## DLC-2 CONSTRUCTION

B3E060201038T05

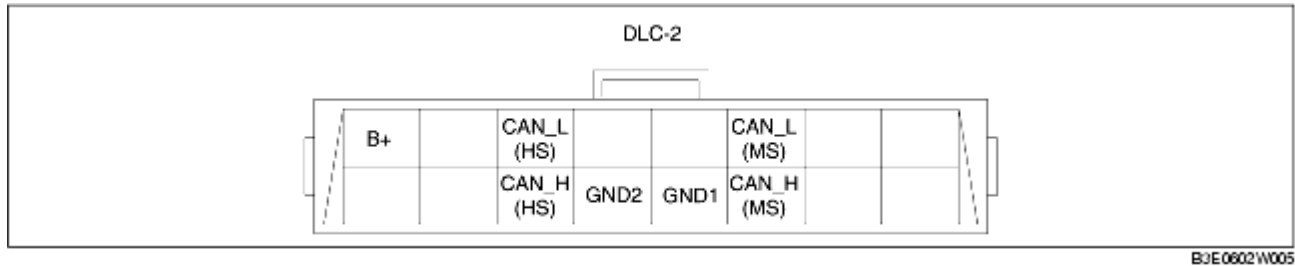
- A connector (DLC-2) conforming to International Organization for Standardization (ISO) standards has been added.
- Shape and terminal arrangement as stipulated by the ISO 15031-3 (SAE J1962) international standard has been adopted for this connector. The connector has a 16-pin construction that includes the CAN\_H (HS), CAN\_L (HS), CAN\_H (MS), CAN\_L (MS), GND1, GND2 and B+ terminals.
